DATE PREPARED: June 11, 2007		ISS PAYLOAD OFFICE PIRN/EXCEPTION FORM		PAGE 1 OF 7	
Doc. No., SSP 57213, Initial Release Rev. & Title: Alpha Magnetic Spectrometer (AMS) Interface Control Document			PIRN No: 57213-NA-0008		
TITLE: AMS (Alpha Magnetic Spectrometer) – On-orbit Operations Envelope Exceedance					
Originator: Name: Trent Martin Agency: NASA JSC AMS Project Office / EA Phone: 281-483-3296 Email: trent.d.martin@nasa.gov		PIRN Type: <input type="checkbox"/> Standard PIRN <input checked="" type="checkbox"/> Exception		FAX Approval Signatures to this Number: 314-777-2866	
Utilization Change Engineer: Name: Leonardo Cornejo Agency: Boeing PEI Phone: 281-226-4644 Email: Leonardo.A.Cornejo@boeing.com		SSCN/CR N/A		RELATED PIRN No.: N/A	
Agency Tracking No.: 57213-0004		SYSTEM/ELEMENT AFFECTED & STAGE EFFECTIVITY: AMS – Launch through End Of Life			
REASON FOR CHANGE OR REQUIREMENT(S) VIOLATION: AMS exceeds on-orbit operational enveloped defined in SSP-57003, Paragraphs 3.1.3.1.1.1.

Requirement Number: 3.1.3.1.1.1
Requirement Title: PAYLOAD ATTACH SYSTEM UNPRESSURIZED
LOGISTICS CARRIER ATTACH SYSTEM ON-ORBIT
OPERATIONAL ENVELOPE

Figure 3.1.3.1.1.1-AMS: AMS Exceedances of Generic AP Envelope (For reference only)

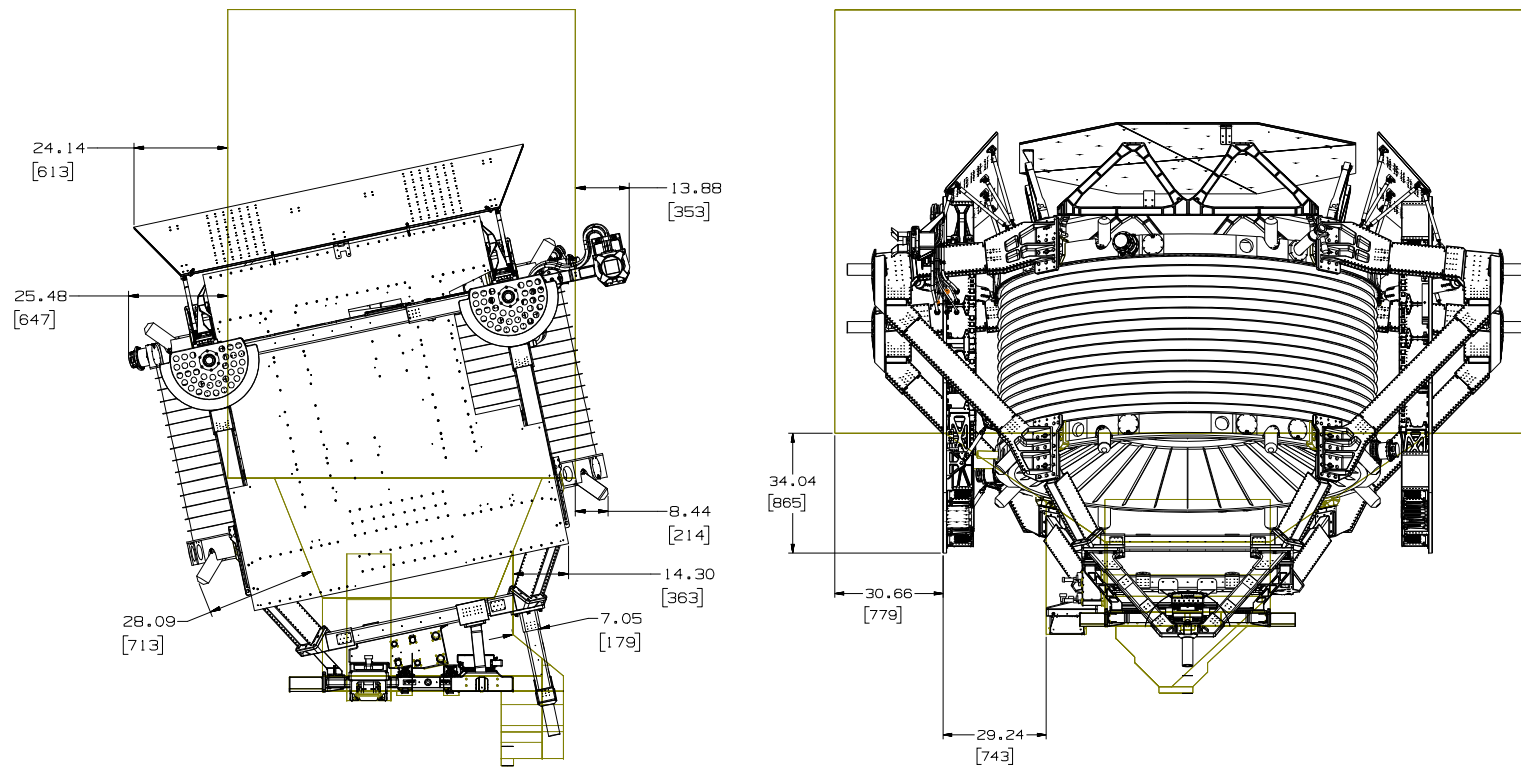
Attached Payloads and equipment shall be designed such that the payload does not exceed the allowable On-Orbit operational envelope in accordance with Figure 3.1.3.1.1.1–1, Operational Envelope. **Except the AMS payload violates this Operational Envelope as shown in Figure 3.1.3.1.1.1-AMS, and figure 15 from MAGIK AI 2279 Rev A.**

The AMS payload inside diameter was set by the diameter of the Tracker flown on STS-91. When the permanent magnet flown on STS-91 was replaced by a superconducting magnet for the ISS flight, the outside diameter had to be extended. Every effort was made to minimize the size of the AMS magnet, but in order to meet the science goals of AMS, the magnet had to be built such that it is larger than the payload envelope of the ISS Attached Payload IRD. This was not helped by the fact that the envelope was not defined until after the AMS magnet diameter was determined. In addition to this envelope exceedance, the payload has been tilted 12 degrees inboard on ISS. This was done for two reasons, 1) to minimize the interferences with the adjacent attached payload and 2) to minimize the blockage of the AMS primary field of view by the ISS solar arrays. In order to assess the impact of these interferences, the AMS payload, along with the ISS payloads office, have performed extensive analyses and testing of these envelope exceedances. The assessments have included MAGIK analyses of payload berthing (MAGIK Action Item #'s 1110, 1146, 1174, 1192, 1254, 1595, 1705, 2172, and 2279), EVA worksite analyses (LMSO Q105743), and NBL tests (Crew Consensus Report 11.12.02). All of these analyses and tests were undertaken to ensure that there will be no physical interferences during all on-orbit phases and maximize the clearances to neighboring payloads.

Approve as written.

Approved as written.

Figure AMS-AA-01 FPMU Installed on S1

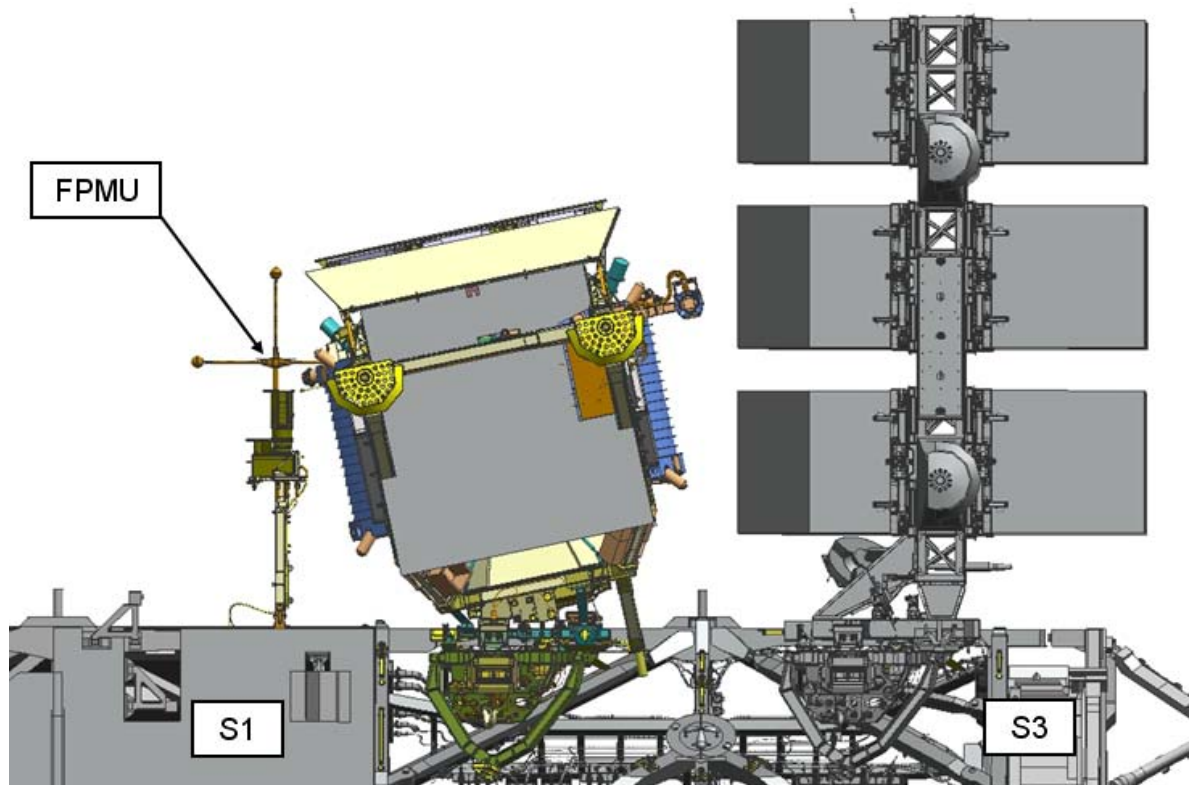
PEI agrees with the EVA analysis reports (on EDMS): D684-13036-01 (EVA Analysis Report AMS to S3 Contingency CAS Release); D684-13037-01 (EVA Analysis Report AMS PPAS and S3 PAS UMA); and D684-13038-01 (S3 EVA Secondary Translation Path with AMS Installed), which identified two AMS violations against SSP57003, EVA requirements: 3.11.1.1 (EVA TRANSLATION PATH INTERFERENCE) and 3.11.2.3 (WORKING VOLUME). Exceptions 57213-NA-0005 and 57213-NA-0006 for these violations were presented to the EVA-AIT and were approved on September 4, 2008. A Floating Potential Measurement Unit (FPMU) is currently installed on S1 and needs to be removed from there prior to AMS installation. See figure AMS-AA-01 FPMU Installed on S1.

1. The Floating Potential Measurement Unit (FPMU) shall be removed prior to AMS installation.

The FPMU is currently installed on Camera Port (CP) 2 and interferes with S3 upper inboard PAS site which is where the AMS will be installed.

Figure AMS-AA-02 (From page 7 on AMS Analysis Result Presentation)

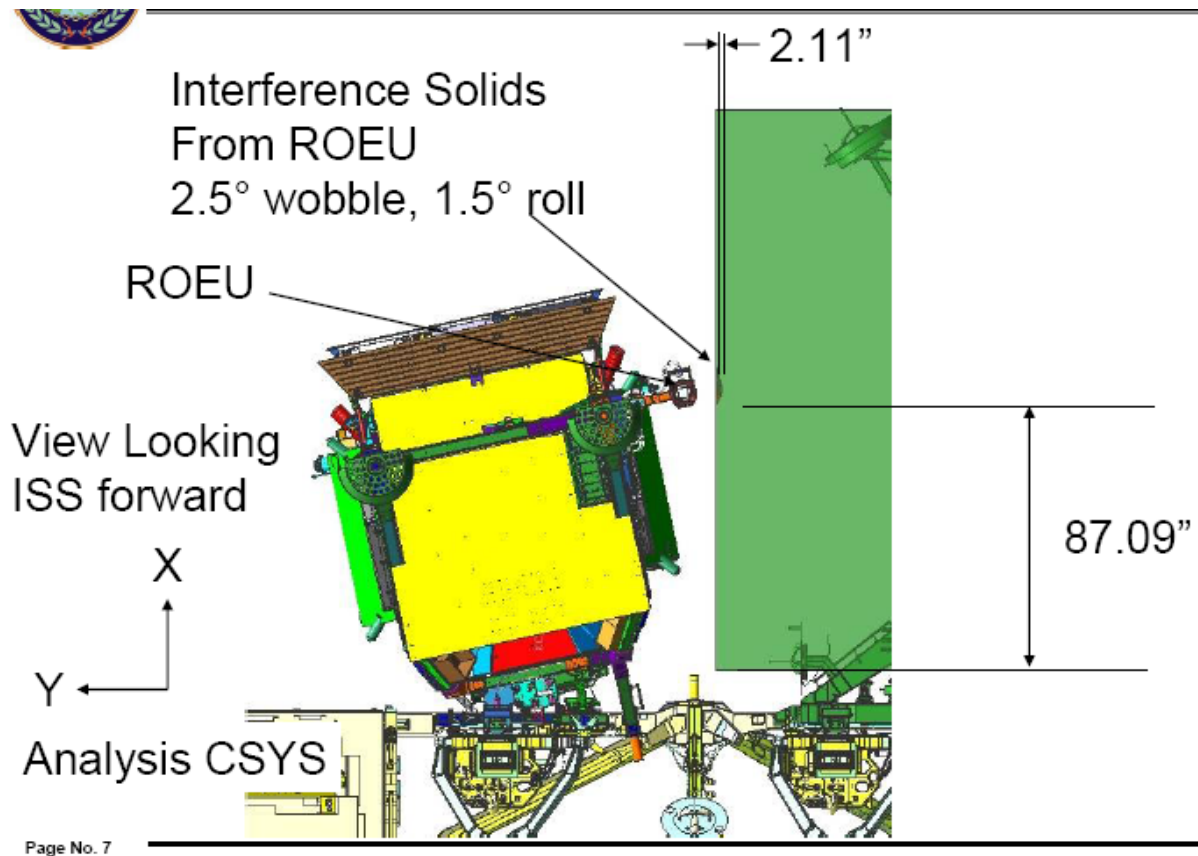
PEI also agrees with the results of the analysis performed by the Assembly Analysis team as documented in presentation: AMS Analysis Results, dated 11/10/08 (Attached to this exception), which shows that in order to avoid any interference between the AMS and the adjacent payload (ELC2 according to the current manifest plan), during AMS installation, the ELC2 62" payload envelope (from the surface of the ELC deck to the height of the generic payload volume) needs to be reduced to 59.8" (2.2" reduction). This number is the result of the maximum misalignment during AMS installation (2.5° wobble, 1.5° Roll) on S3 upper inboard. Figure AMS-AA-02 below from page 7 in Assembly Analysis Results shows the reduction on ELC2 to avoid the interference during AMS installation. The results of this analysis were presented to OM6 on 11/18/08 and obtained their concurrence. Same analysis was presented to the End to End Berthing Integration Team (EBIT) on December 3, 2008. The EBIT had no issues with this analysis.

2. No payload/ORU as installed on the ELC's top deck at S3 upper outboard adjacent to AMS (Currently ELC2) shall be taller than 59.8" (from the surface of the ELC deck to the height of the generic payload volume), as defined by the Assembly Analysis report: AMS Analysis Results.

According to the current manifest plan, the adjacent payload to the AMS is ELC2. The ELC payload envelope in the direction of the AMS is 62" (from the surface of the ELC deck to the height of the generic payload volume). The Assembly Analysis team performed an analysis that shows a maximum of 59.8" for the ELC2 payload envelope to avoid any interference during the AMS installation on S3 upper inboard.
